**Addendum #1 IFB 22-15**

To: Marginal Combined Sewers Rehabilitation Project

Re: Bid Opening Extension and responses to requests for information

CITY OF SOMERVILLE, MA  
 MARGINAL COMBINED SEWERS REHABILITATION PROJECT

SHEET  
**SK-ADD1-1**

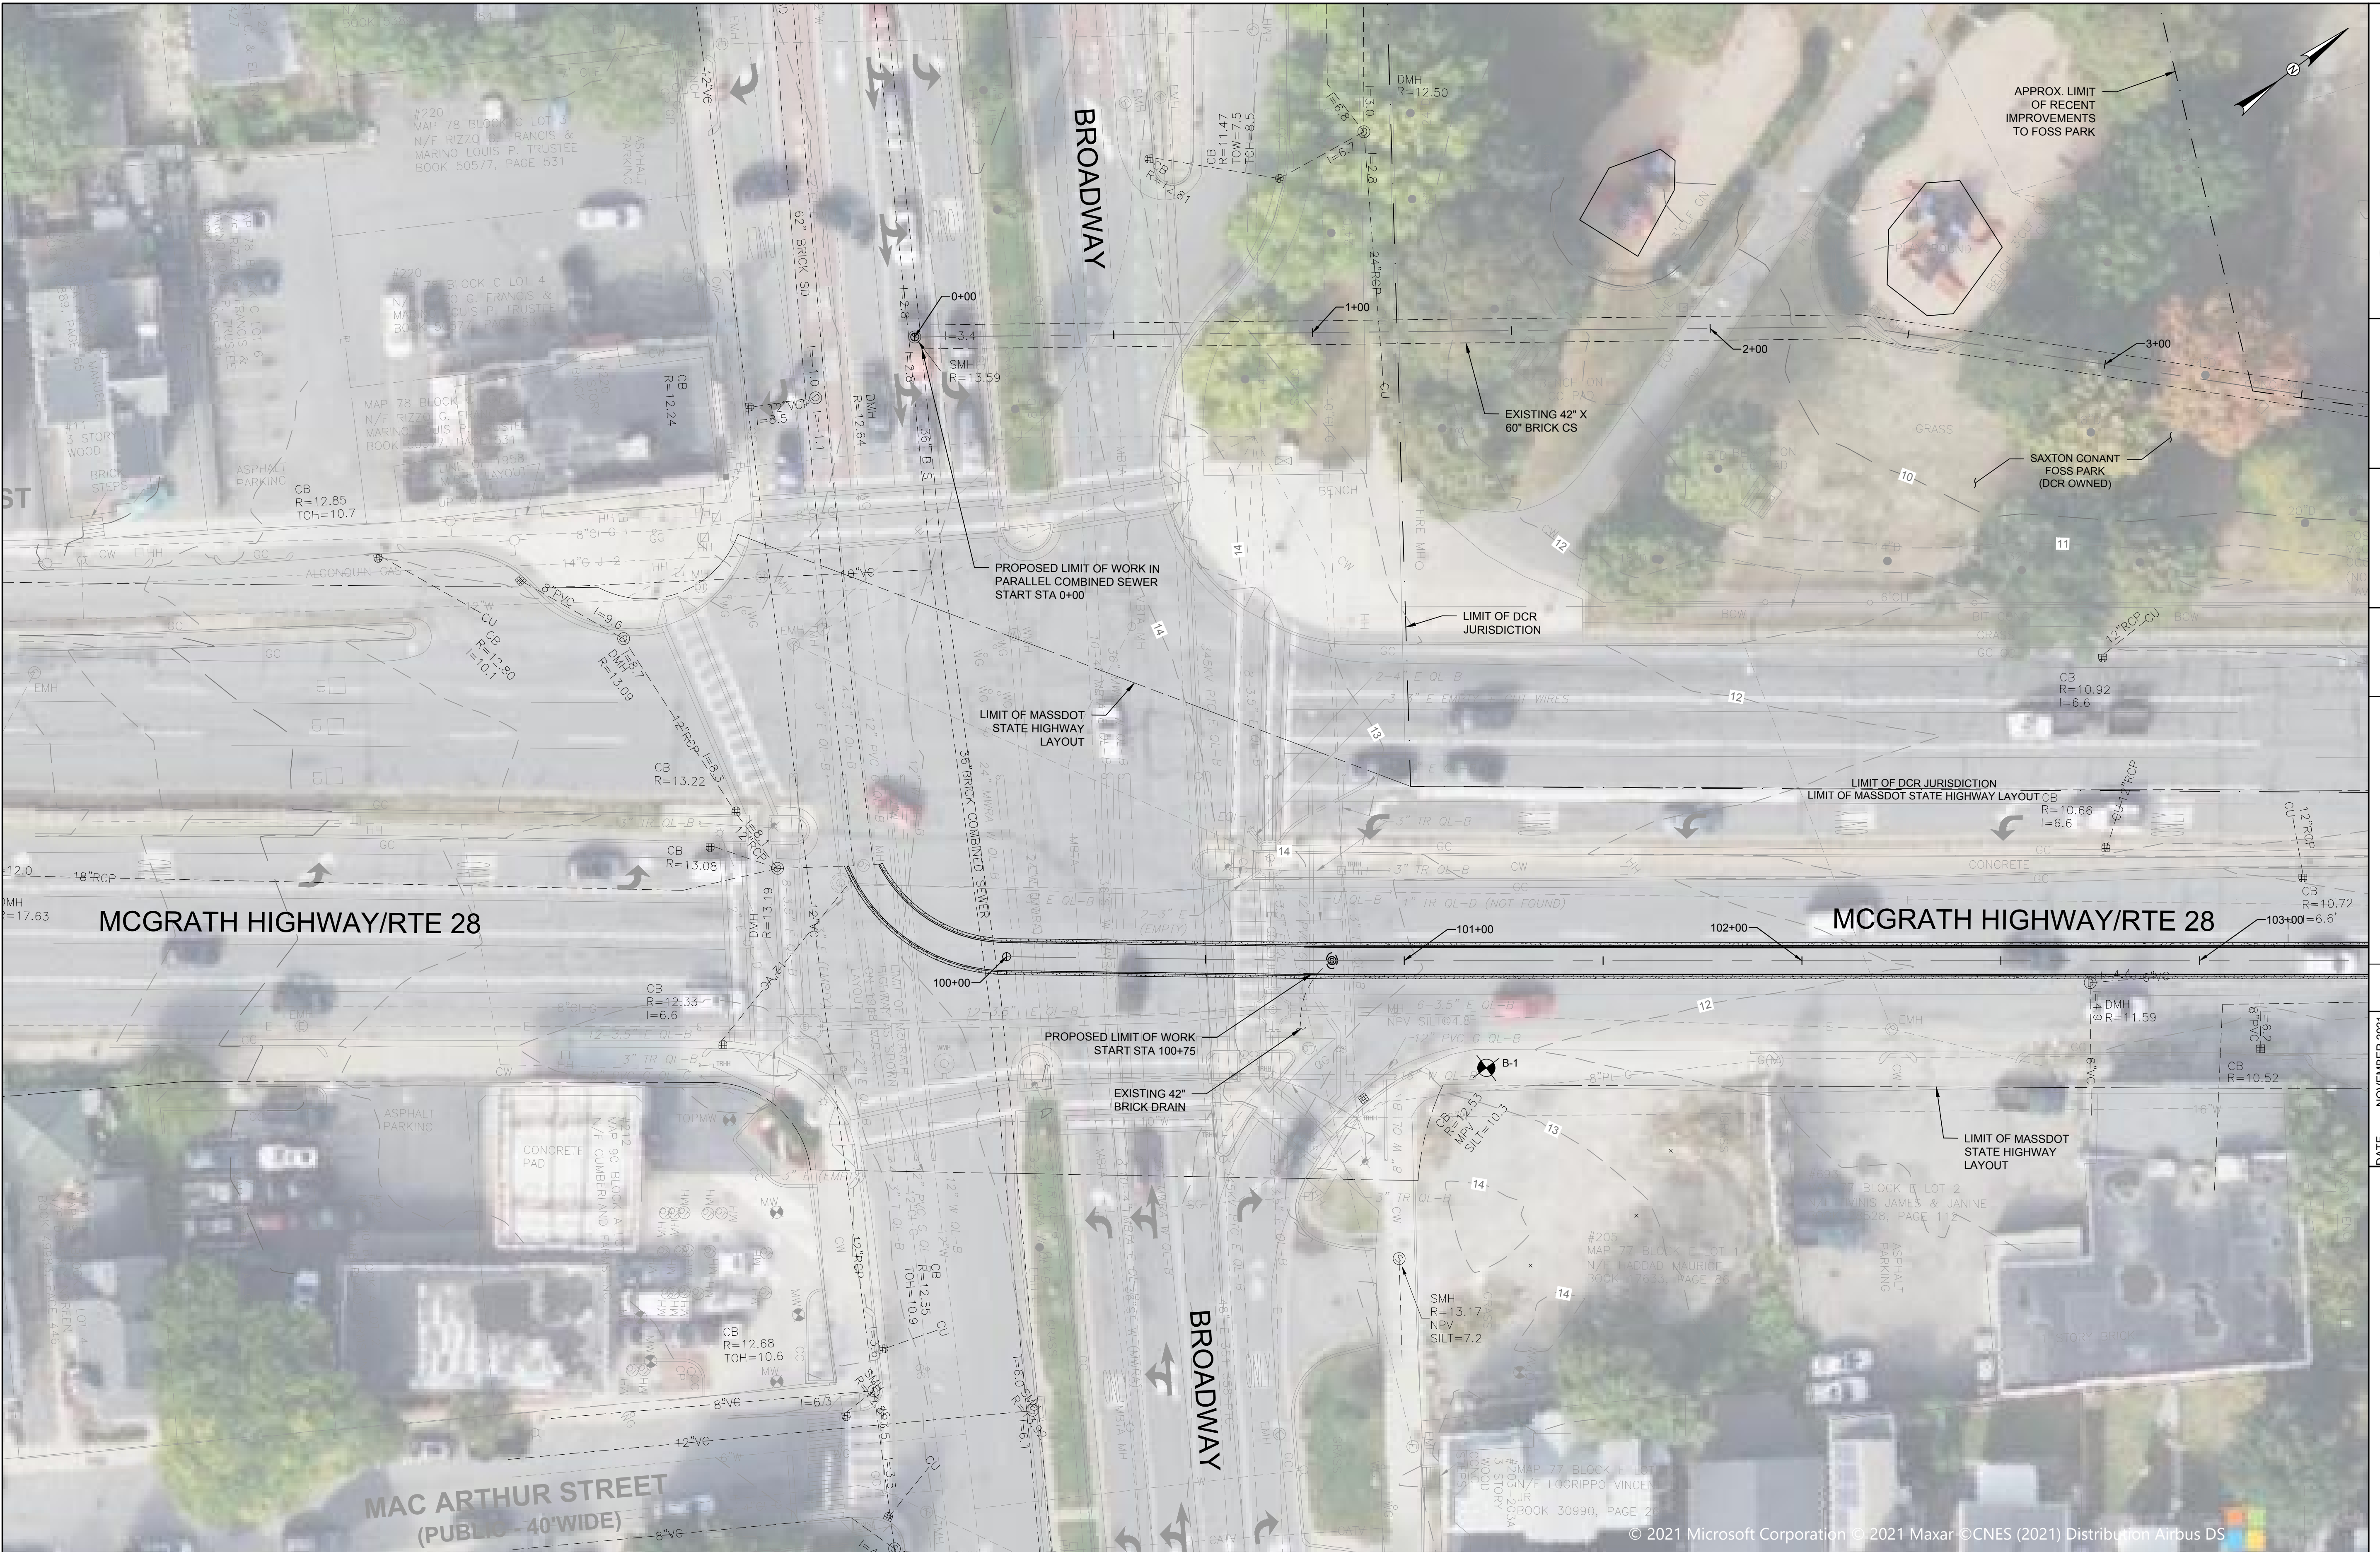
<b>Question</b>	<b>Answer</b>
Please provide a figure showing the existing sewer and drainage infrastructure upstream (south) of the work in the McGrath Highway intersection with Broadway.	Please see attached SK-ADD1-1 showing the existing infrastructure in the intersection at the southern limit of the work as requested. Bidders attention is directed to Specifications 01010 and 02761 describing the designers intended internal dry weather bypass approach.
